This Service Information bulletin supersedes SI M51 03 15 **dated August 2015.**

Recall Campaign 15V-450: Side Impact Performance

NEW F56 (Cooper S, JCW Hardtop 2 Door)

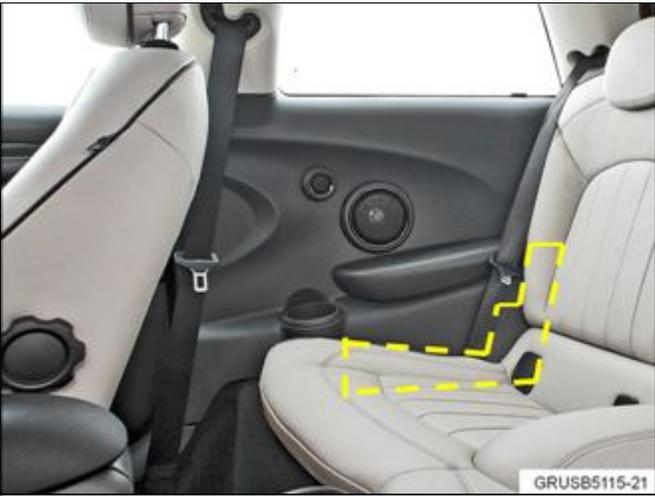
The vehicle's side structure is designed to help absorb energy in the event of a side collision. Due to vehicle build variation, some of the vehicles may marginally exceed a NHTSA test requirement. MINI is performing a voluntary upgrade to these vehicles. Additional energy-absorbing material between the rear interior side panels and the vehicle structure will be added to help enhance occupant protection in the event of a side collision.

Please note that many vehicles affected by this repair (installation of the "L-Pad") are also affected by the installation of a "Patch" as illustrated in the chart below.

<p style="text-align: right; font-size: small;">GRUSB5115-21</p>	<p>Install a molded structural foam pad to both the left and right rear side trim panels.</p> <p>The pad is applied to the inside surface of the panel, and is not visible either from inside the vehicle nor from the outside.</p> <p>The general location is indicated on this passenger side panel by the dotted line.</p>
--	---
